HISTORIC AND DESIGN REVIEW COMMISSION

HDRC CASE NO: 2019-415
ADDRESS: 813 BURLESON ST
LEGAL DESCRIPTION: NCB 1301 BLK 2 LOT 17
ZONING: R-5, H
CITY COUNCIL DIST.: 2
DISTRICT: Dignowity Hill Historic District
APPLICANT: Melissa Iruegas/River City Acquisitions
OWNER: Kyle Braunlich
TYPE OF WORK: Front porch modifications
APPLICATION RECEIVED: July 18, 2019
60-DAY REVIEW: September 16, 2019
CASE MANAGER: Edward Hall
REQUEST:

The applicant is requesting a Certificate of Appropriateness for approval to:

LOT 17, BLOCK 2
N.C.B. 1301

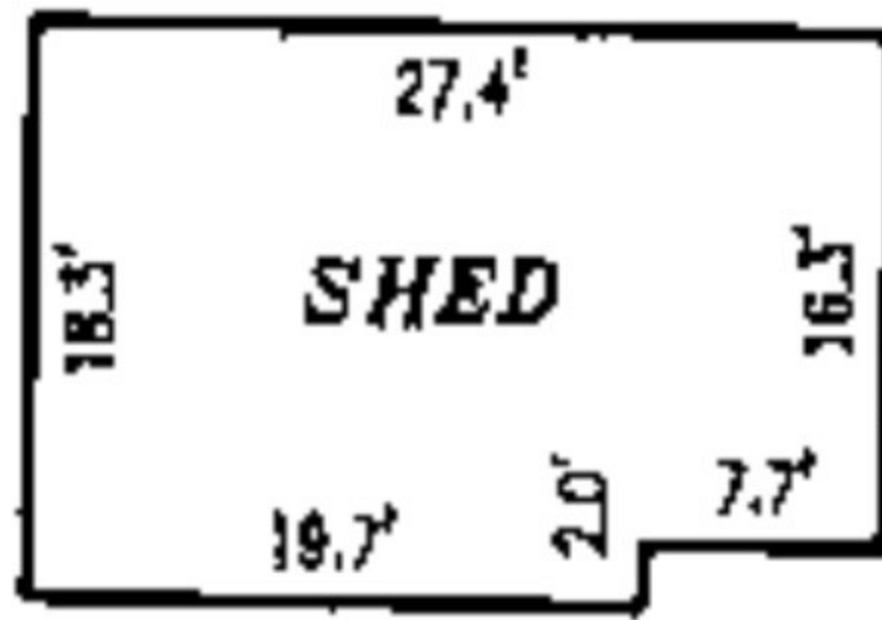
- g. CONCRETE SIDEWALK REPLACEMENT – The applicant has proposed to replace the existing, concrete sidewalk in-kind. Staff finds this replacement to be appropriate; however, the existing sidewalk flare should be matched, as noted on the site plan/survey.

- vi. That the sidewalk flare match that which previously existing on site, as noted in finding g.

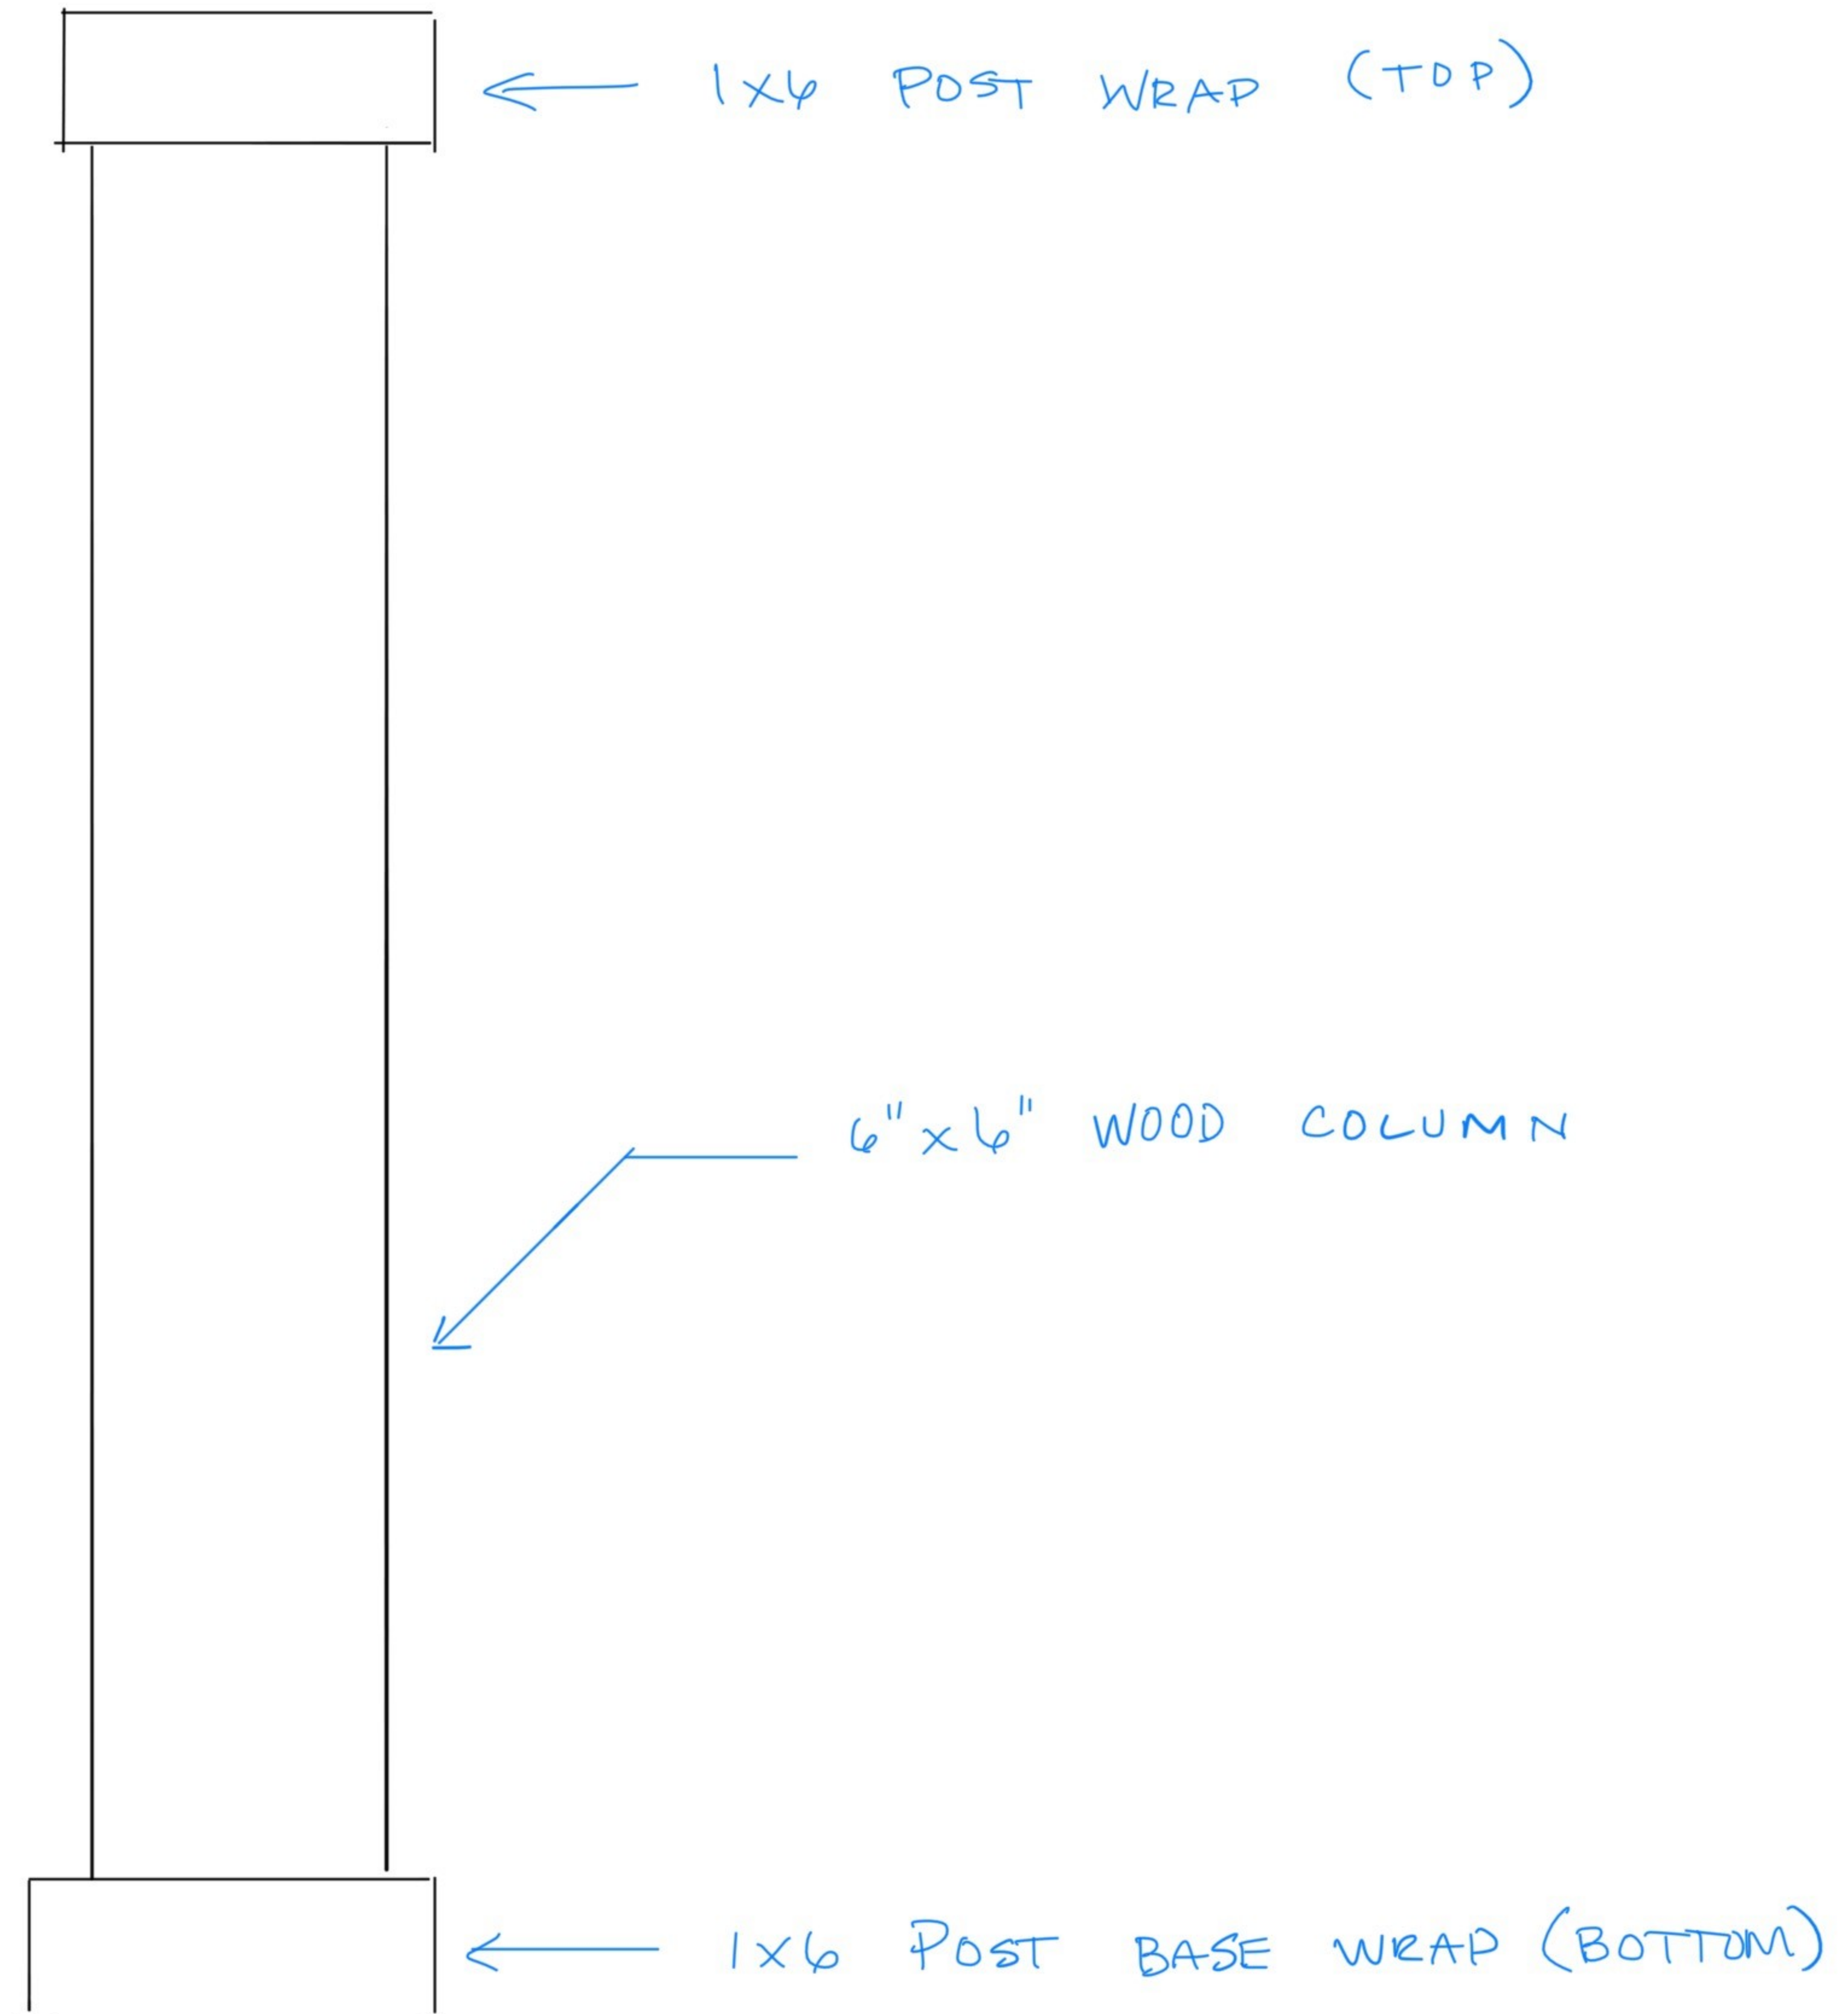
- d. PORCH STEPS – As noted in finding b, the structure currently features concrete steps that the applicant has proposed to demolish and replace with wood steps. Staff finds that the proposed porch steps should feature a common width of the sidewalk apron/flare. A detail of this width is to be submitted to OHP staff for review and approval prior to the issuance of a Certificate of Appropriateness.

- e. PORCH COLUMNS – The applicant has proposed to replace the existing, non-original wrought iron porch columns with six inch square wood columns. The applicant has noted that the proposed columns will feature both base and capital trim. Staff finds the proposed column replacement to be appropriate; however, staff finds that the proposed columns should feature chamfered corners. An updated column detail is to be submitted to OHP staff for review and approval prior to the issuance of a Certificate of Appropriateness.

- f. PORCH RAILINGS – The applicant has proposed to install wood porch railings. The applicant has provided a detailed drawing noting both top and bottom rails for the proposed porch. Staff finds the installation of porch railings to be appropriate; however, staff finds that the porch railings should be simple in design as to not appear original. The proposed railings should feature both a top and bottom rail. The bottom rail should feature a vertical orientation and should be installed approximately three to four inches above the porch decking. Both top and bottom rails should be constructed from 2"x4" members. The proposed railing should not feature an overall height of more than three (3) feet.

- iii. That the proposed porch steps match the width of the sidewalk flare. A detail of this is to be submitted to staff for review and approval prior to the issuance of a Certificate of Appropriateness as noted in finding d.

- iv. That the proposed columns feature chamfered corners. An updated column detail is to be submitted to staff for review and approval prior to the issuance of a Certificate of Appropriateness as noted in finding e.

- v. That the proposed porch railings feature both a top and bottom rail. The bottom rail should feature a vertical orientation and should be installed approximately three to four inches above the porch decking. Both top and bottom rails should be constructed from 2"x4" members. The proposed railing should not feature an overall height of more than three (3) feet.
